Hapeville
georgia

DESIGN REVIEW COMMITTEE

July 17, 2024 6:00 PM

AGENDA

1/4" = 1'-0"

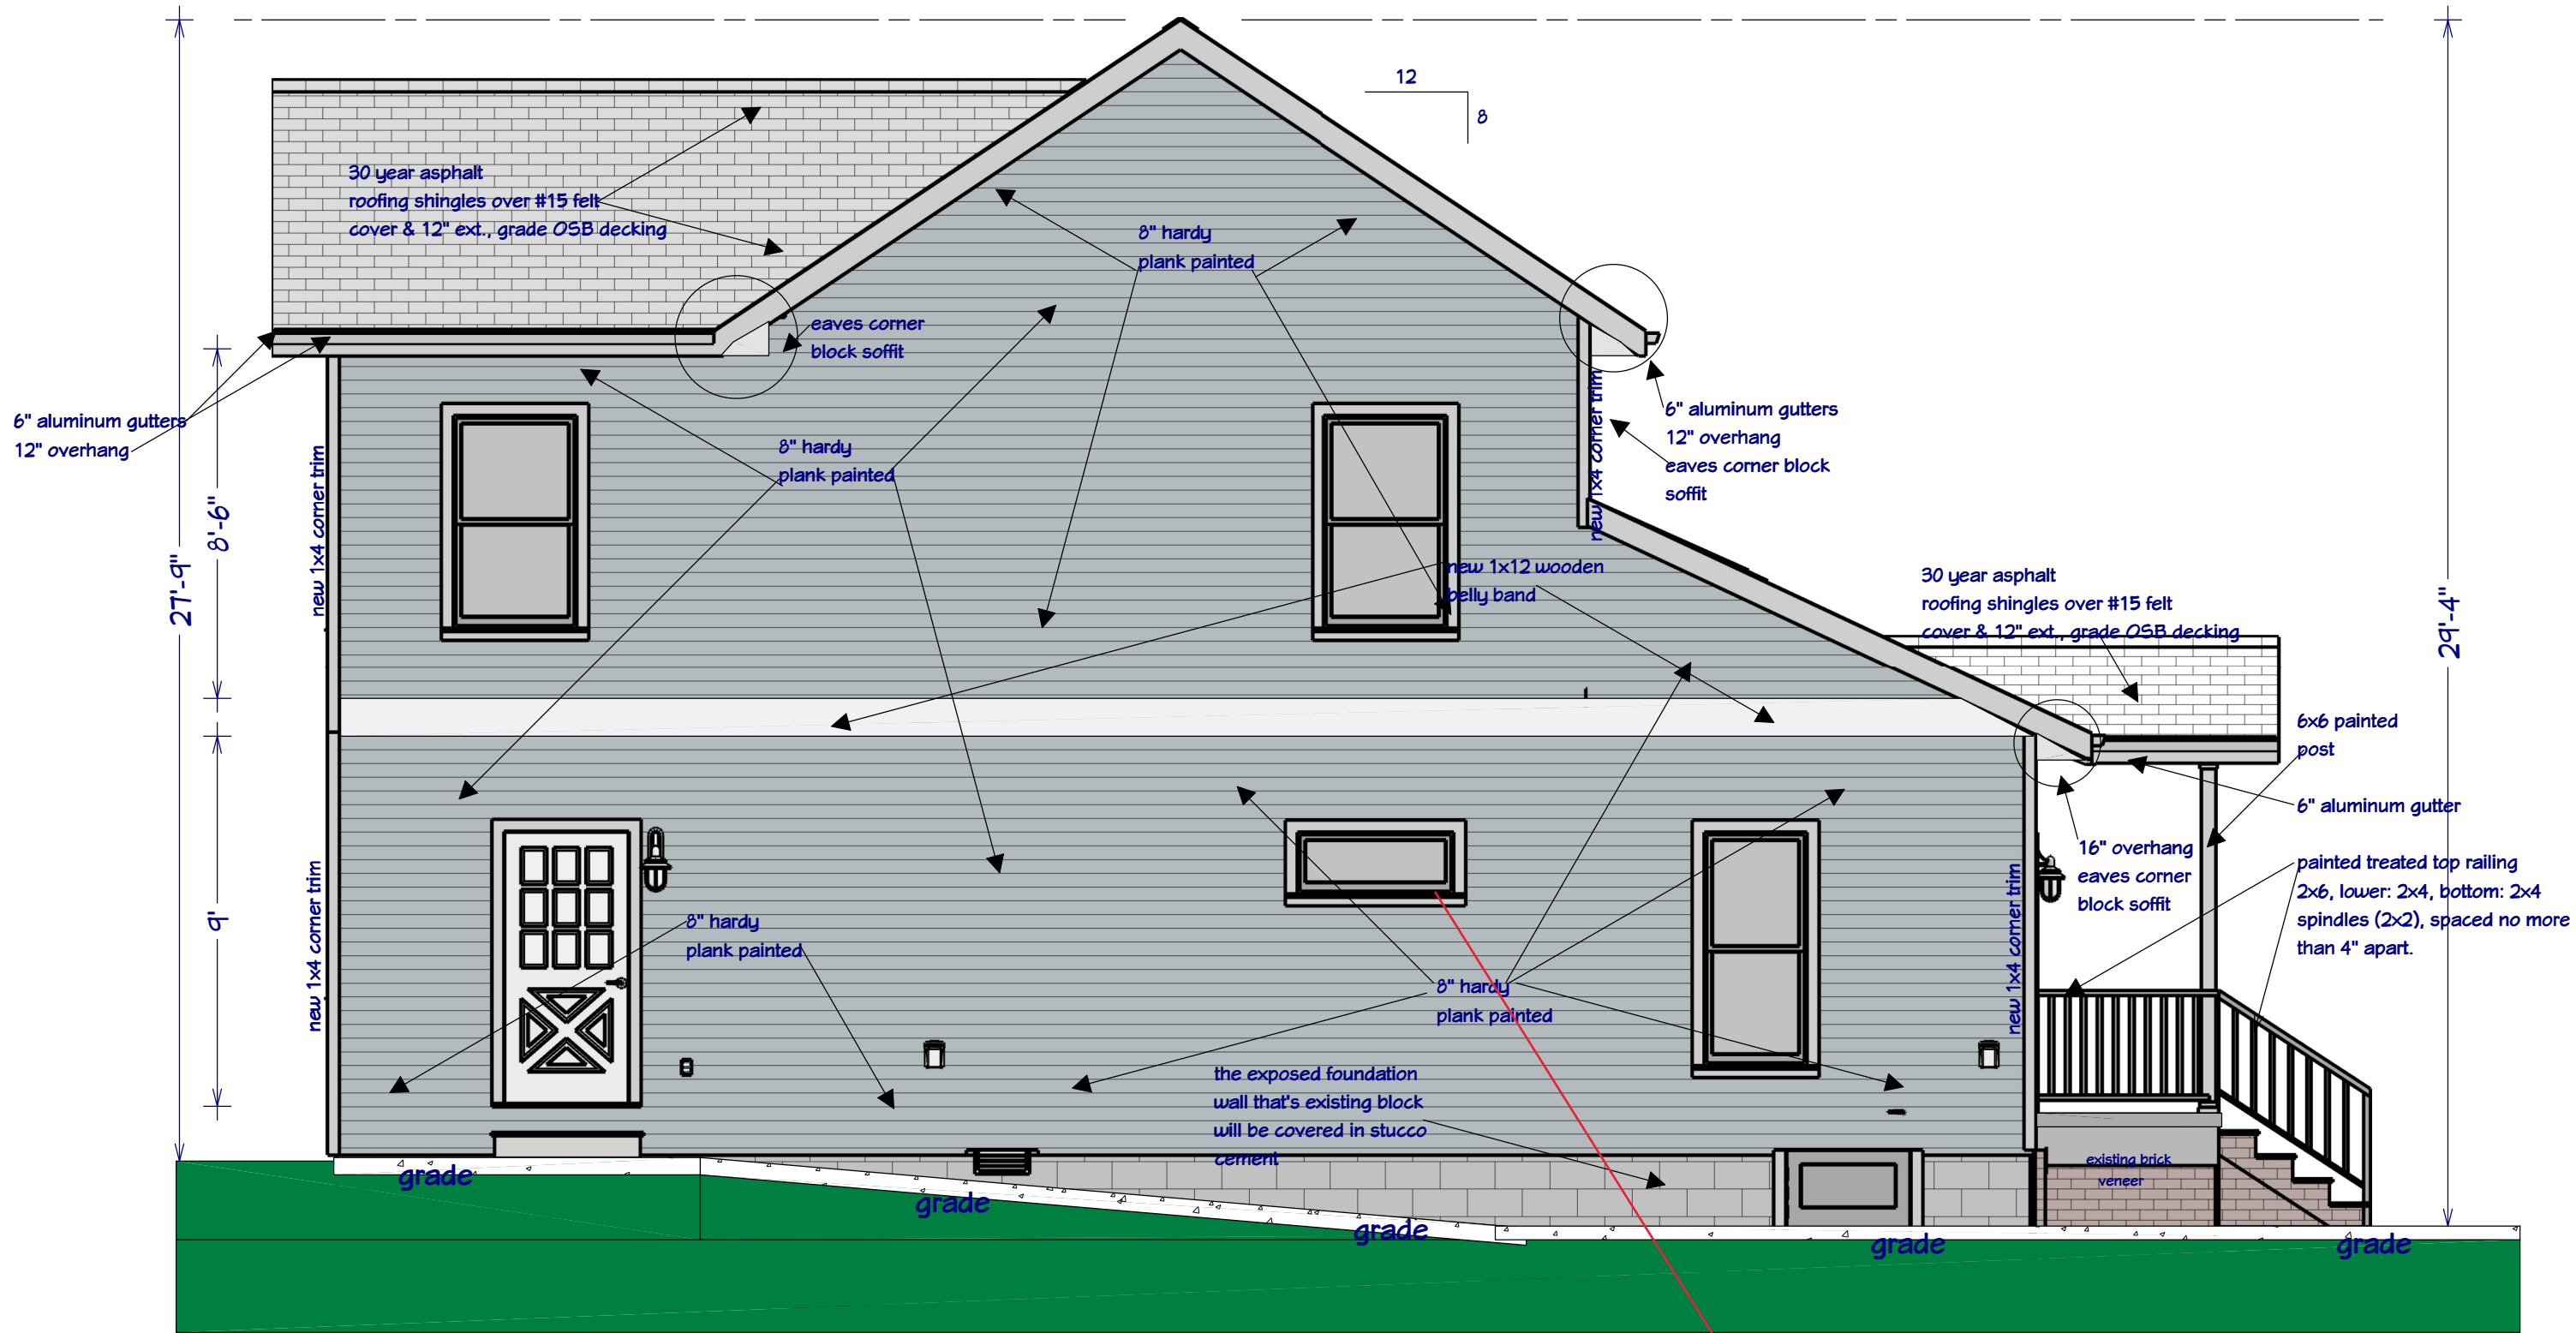
- The slope on the front porch gable is not the same slope as constructed (proposed front elevation). This should be corrected.
- The window sizes on the front second floor plans do not match the new windows as installed (Item #4 in Applicant letter, proposed floor plan-2nd floor). This should be corrected.

- The soffits are now shown with eaves blocks (item #6 of Applicant letter) **instead** of sloped soffits as required from the meeting and as shown and approved from previous submissions (all elevations). The DRC directed the applicant to keep the sloped soffits and correct during construction when application revisions are approved.

- A 12” overhang is still shown on the Proposed Left Side Elevation though a 16” overhang is requested and shown on the other 3 elevations.
- The proposed right-side and left-side elevations still show fixed transom windows, yet the installed windows are described as operational (Item #5 indicated in the letter dated June 10, 2024).

- Item #2 states "We are requesting to trim the windows with 6" x 2" recessed hardy plan on to the sealed structured. Surrounding the window with the approved sized cement hardy plank trim." **Why is this described as recessed?** The trim is to provide the appearance of a recessed window, not trim. It is recommended the DRC see a detail drawing for the proposed trim.

- A 2" sill (wood, hardy-plank or vinyl) has been called out on the proposed front elevation drawings and in Item #3 of the applicant letter. It is recommended that the DRC see the proposed sill material/design detail.
